RENESAS TECHNICAL UPDATE

Product Category	MPU & MCU	Document No.	TN-16C-A192A/E	Rev.	1.00
Title	Errata to R32C/118 Group Hardware Manual		Information Category	Technical Notification	
Applicable Product	R32C/118 Group	Lot No.	Reference Document	R32C/118 Group Hardware Manual Rev. 1.00 (REJ09B0534-0100)

This document describes corrections to the R32C/118 Group Hardware Manual, Rev. 1.00.
The corrections are indicated in red in the list below.

Figure 8.1 Clock Generation Circuitry

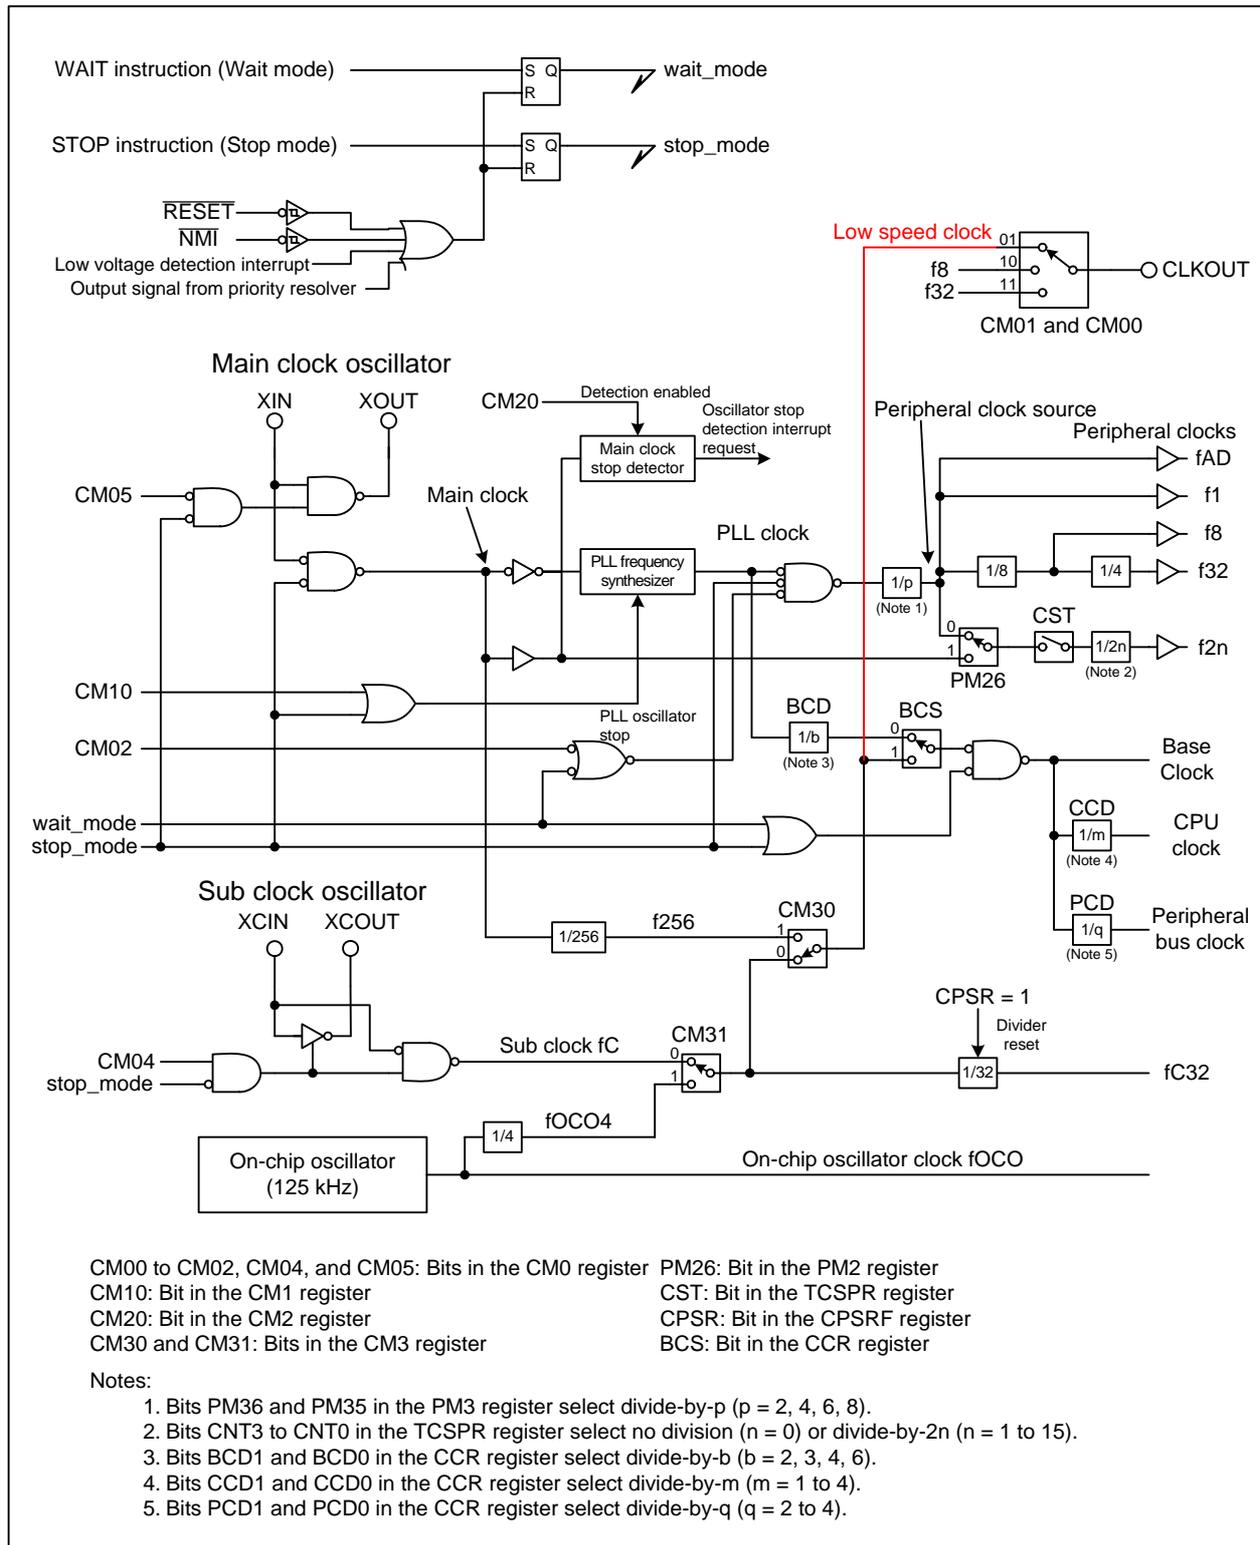
•Page 97 of 615, Figure 8.1 is corrected as follows:

Figure 8.19 State Transition (when the on-chip oscillator clock is used)

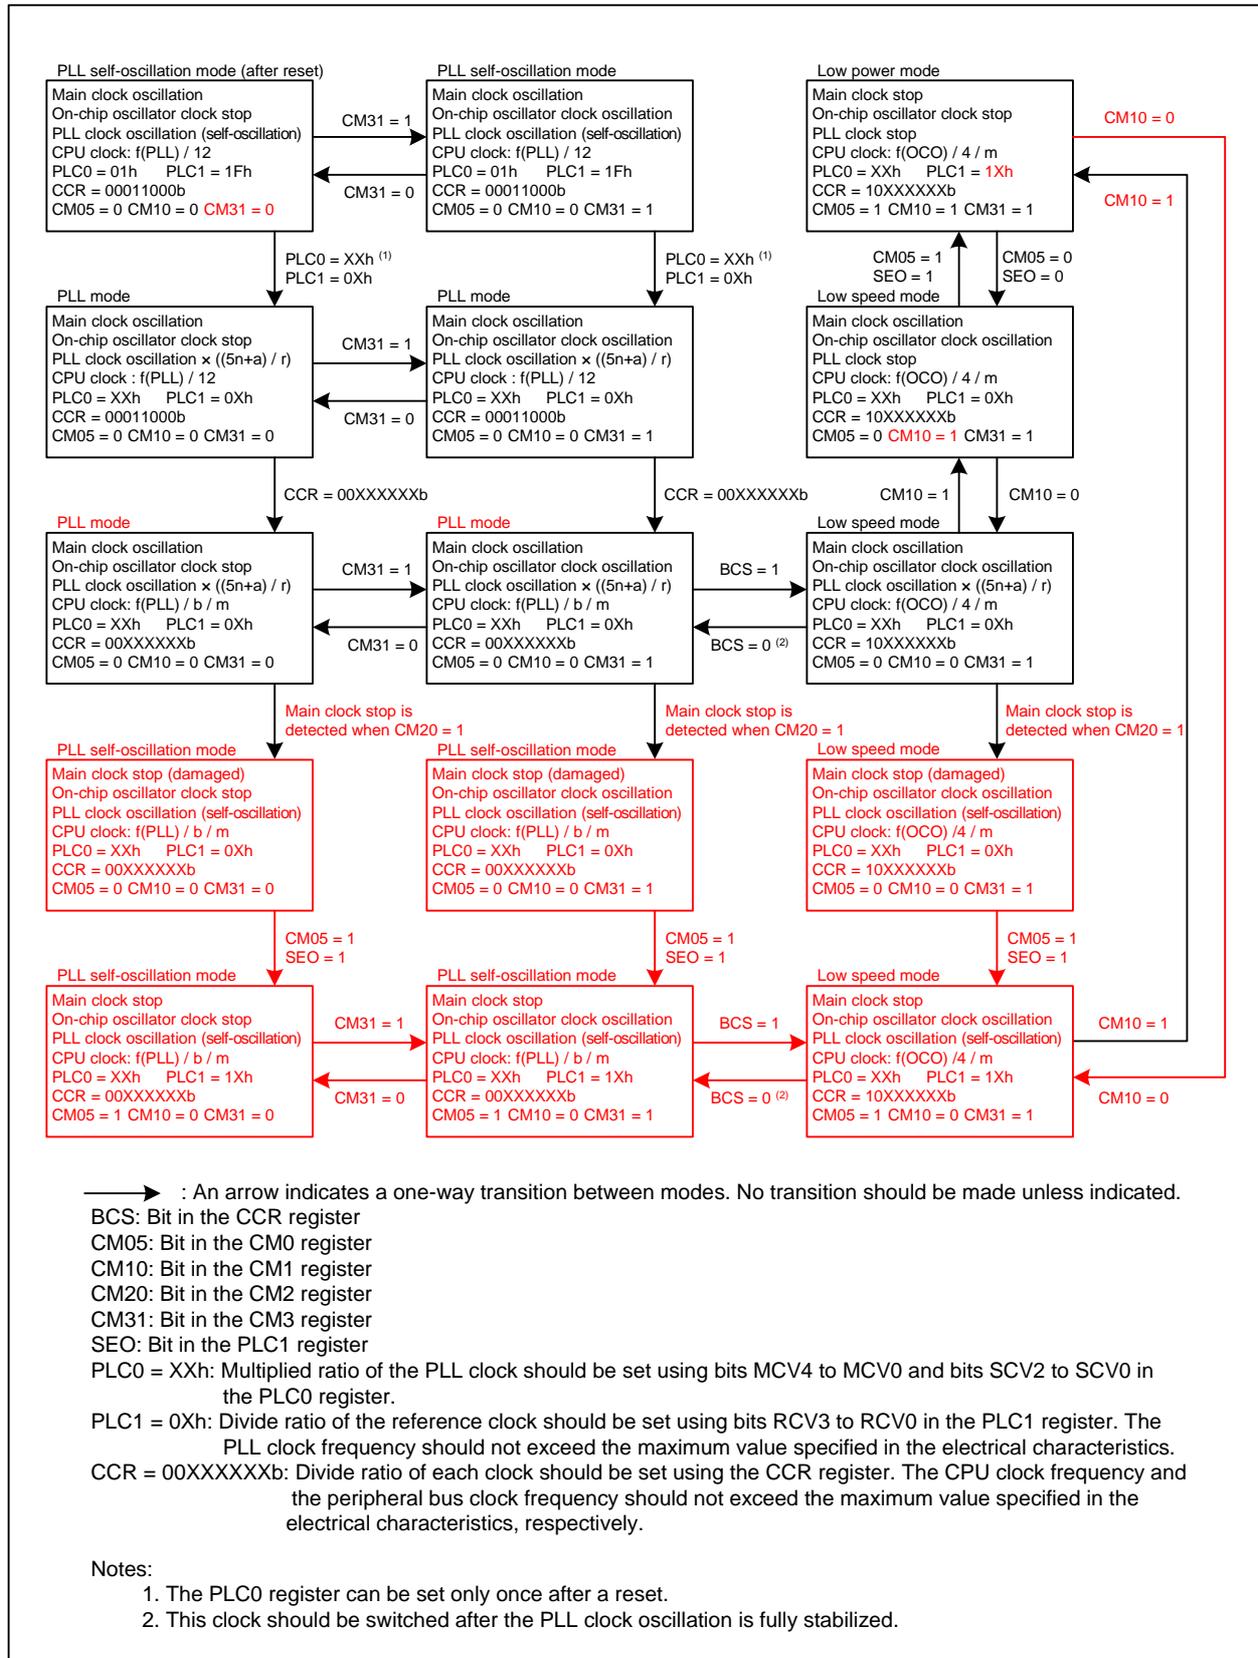
•Page 117 of 615, descriptions of “CM31 = 1” in the first row and “CM10 = 0” in the second row in Figure 8.19 are corrected, and the flowchart are clarified as follows:

(Note 3 “The CM05 bit is not set to 1 when an oscillator stop is detected through the oscillation stop detector.” is deleted from Figure 8.19)

Figure 9.15 ALE Signal and Address Bus/Data Bus

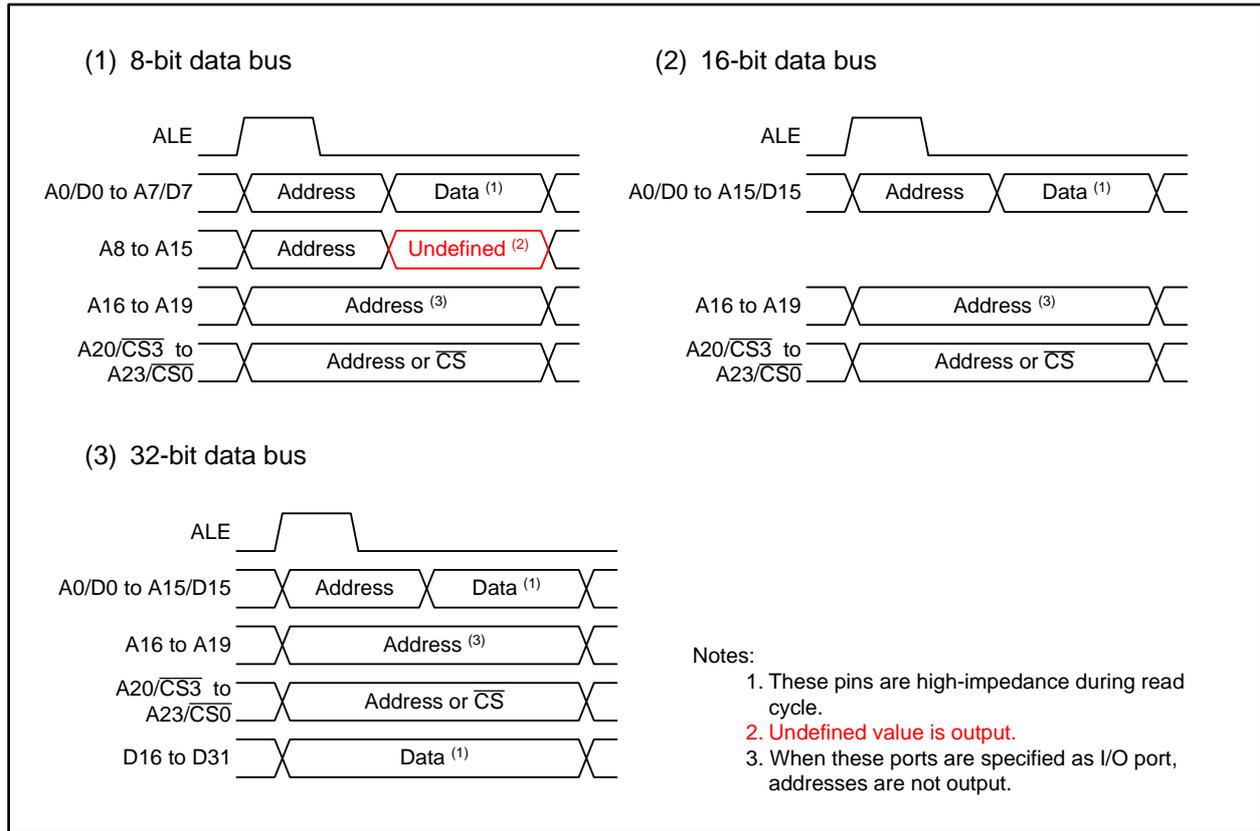
•Page 145 of 615, Figure 9.15 is corrected as follows:

Figure 11.8 Priority Resolver

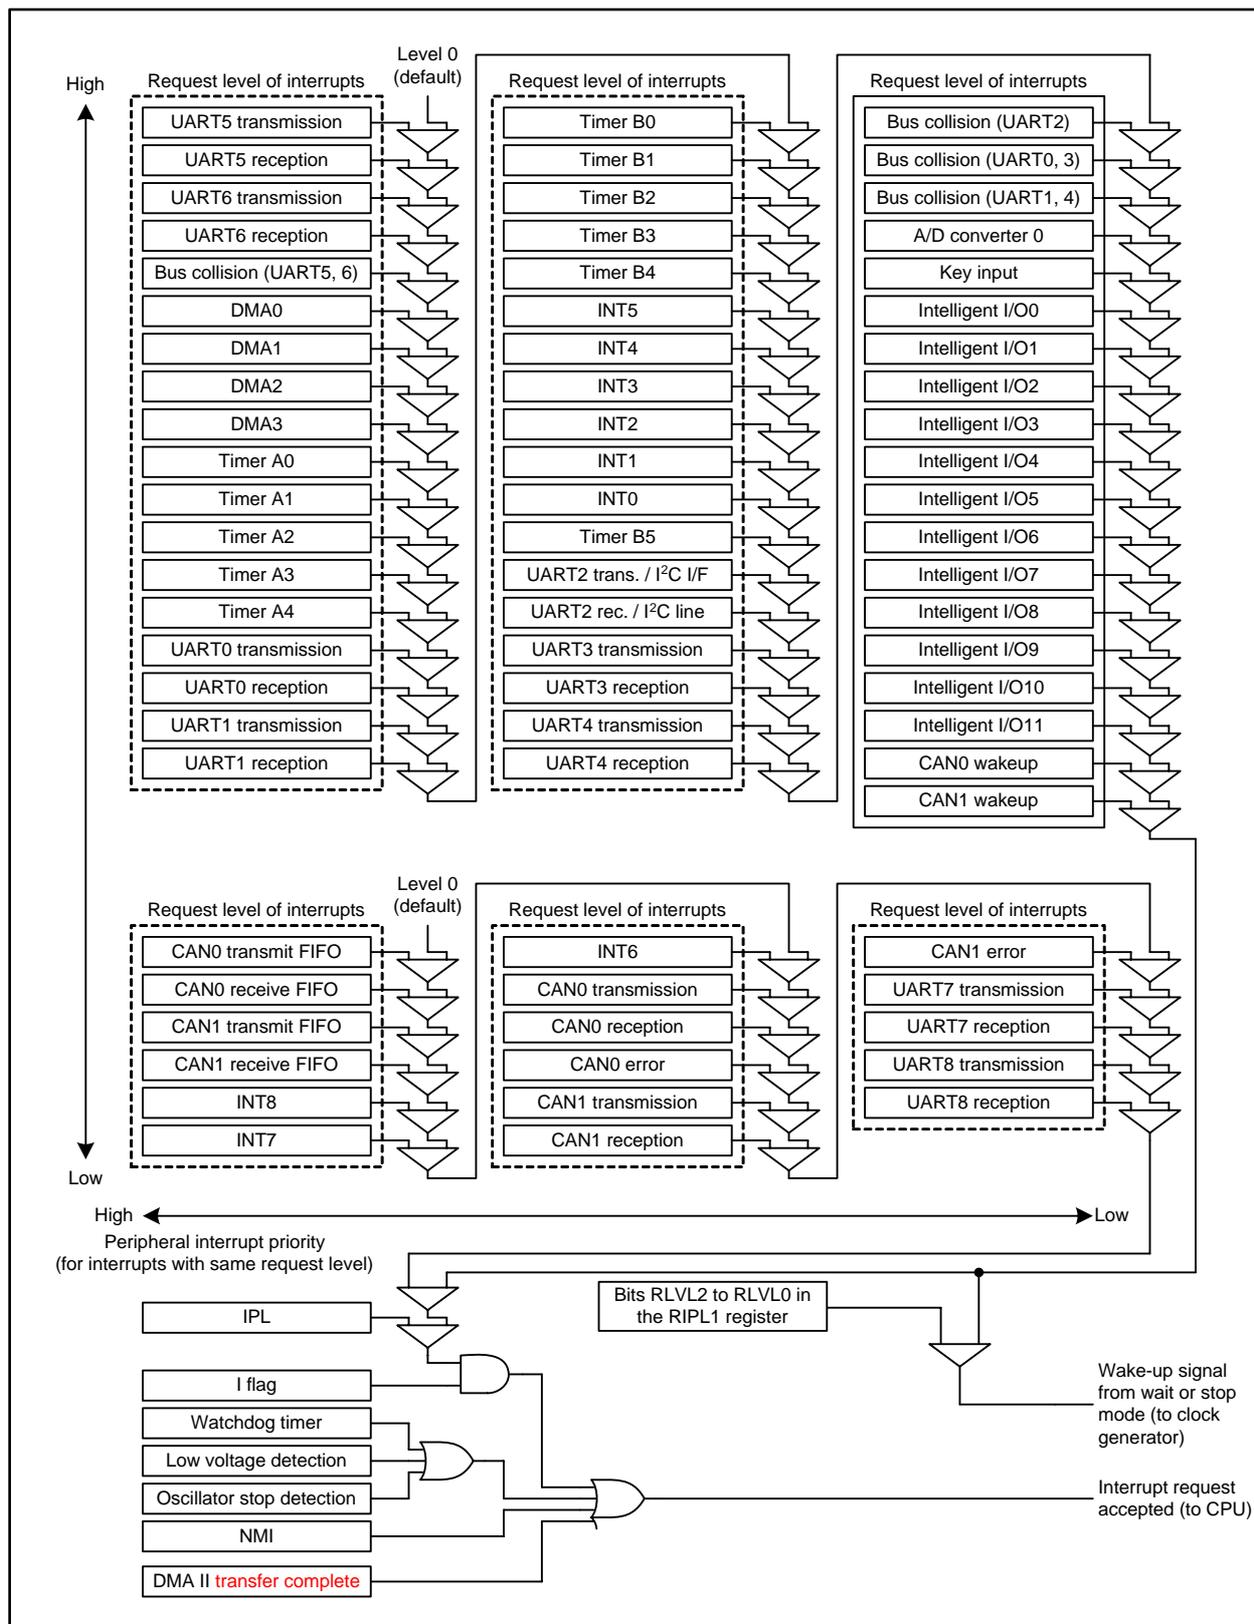
•Page 172 of 615, Figure 11.8 is corrected as follows:

(Description "Bits RLVL2 to RLVL0 in the RIPL2 register" and associated signal lines are deleted from Figure 11.8)

Figure 16.2 Timer B Configuration

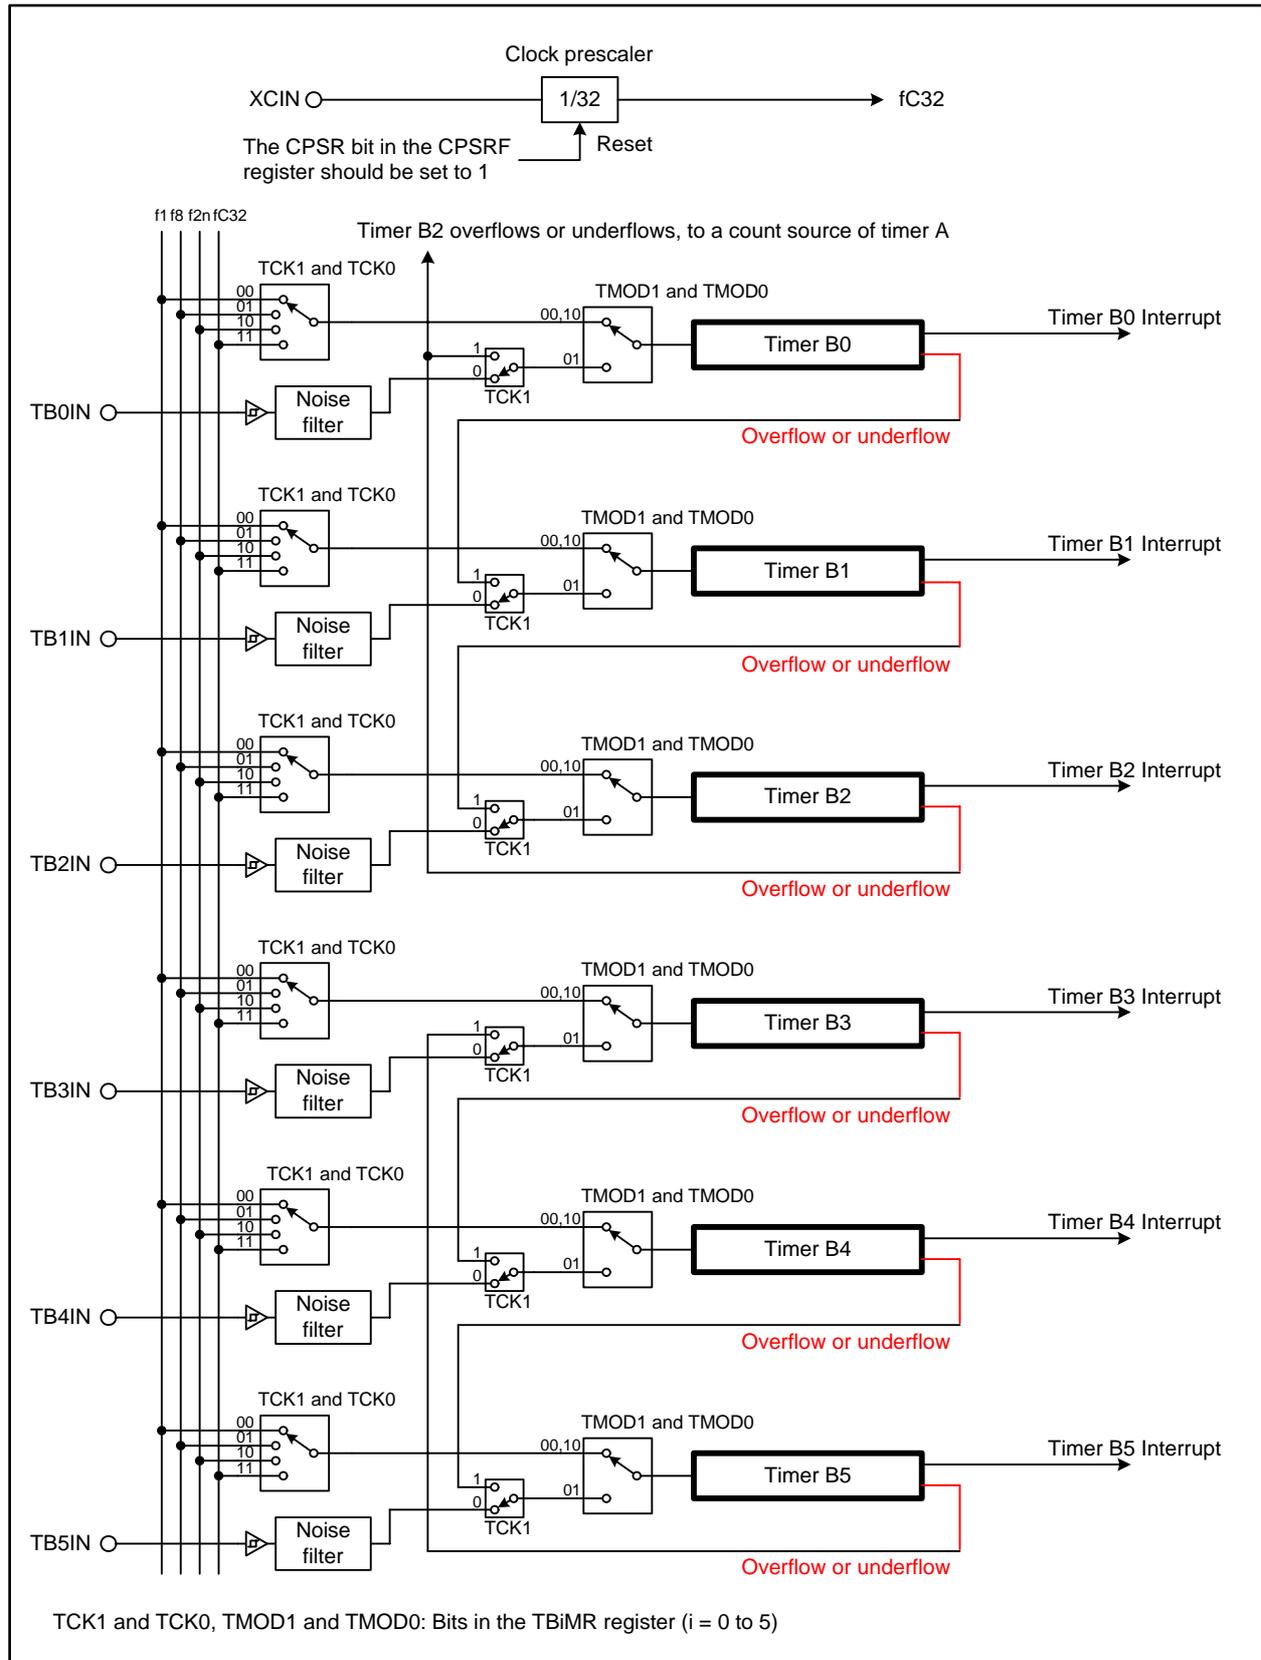
•Page 210 of 615, Figure 16.2 is corrected as follows:

Figure 27.13 Read Timing

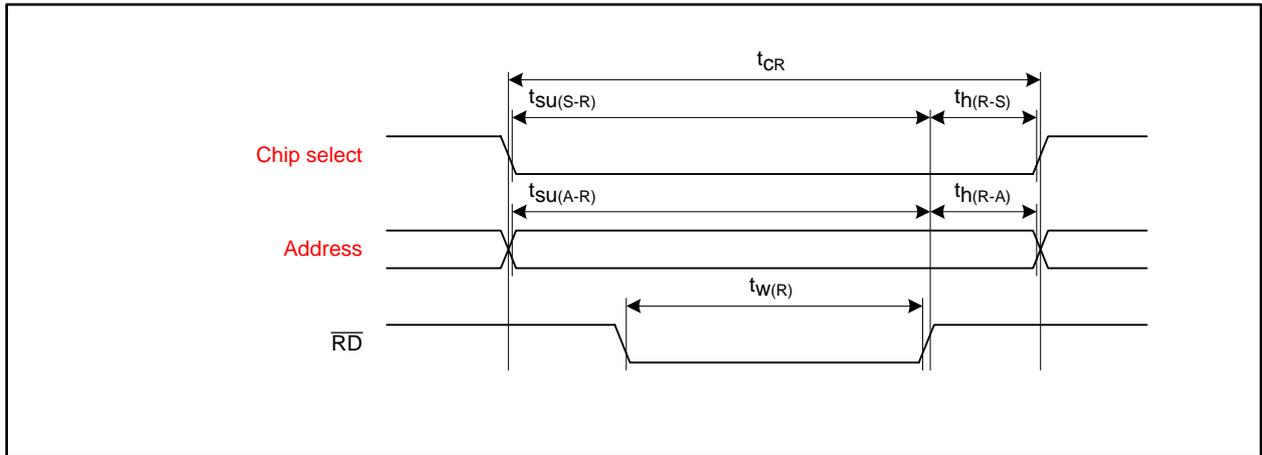
•Page 535 and 537 of 615, descriptions in Figures 27.13, 27.14, and 28.5 are corrected as follows:
